# Access Compliance Report

## Public Rights-of-Way

Intersection ID: 10337	Main Street: E_36TH_ST	Cross Street: SPENCER_ST	Location:	N
ADA ID: 2605F98AF2F6	Ramp Type: Perp	Initial Pass/Fail: Fail	Overall Compliance: No	Severity Score: 8.75
Codes/Mitigation Info/Possible Solution		Field Measurements/Component Compliance

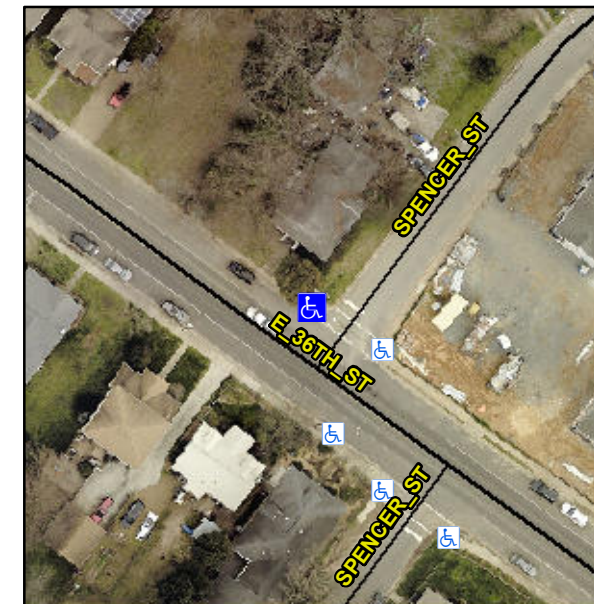
**Not Found, R304.5.1**

Compliance	Description	Data	Compliance	Description	Data
N/A	Ramp Length (in)	48.0	Yes	Ramp Slope (%)	5.0
No	Ramp Width (in)	47.5	Yes	Ramp XSlope (%)	1.8
N/A	Flare Type LT	N/A	N/A	Flare Type RT	N/A
N/A	Flare Slope LT (%)	N/A	N/A	Flare Slope RT (%)	N/A
N/A	Flare Traversable LT?	N/A	N/A	Flare Traversable RT?	N/A
N/A	Landing Length (in)	N/A	N/A	DWS Provided?	N/A
N/A	Landing Width (in)	N/A	N/A	DWS Contrast?	N/A
N/A	Landing Slope (%)	N/A	N/A	DWS Length (in)	N/A
N/A	Landing X Slope (%)	N/A	N/A	DWS Full Width?	N/A
N/A	Landing Curb? (Y/N)	N/A	N/A	DWS Offset (in)	N/A
N/A	Shared Landing?	N/A			
N/A	Gutter Ponding?	N/A	N/A	Gutter Slope (%)	N/A
N/A	Gutter Lip Ht (in)	N/A	N/A	Gutter X Slope (%)	N/A
N/A	Painted X Walk1?	Yes	N/A	Painted X Walk2?	N/A
	X Walk 1 Direction	To SE		X Walk 2 Direction	N/A
N/A	X Walk 1 Width (in)	112.0	N/A	X Walk 2 Width (in)	N/A
	X Walk 1 Slope (%)	1.7		X Walk 2 Slope (%)	N/A
	X Walk 1 X Slope (%)	1.8		X Walk 2 X Slope (%)	N/A

**Remove & Replace Entire Ramp.**
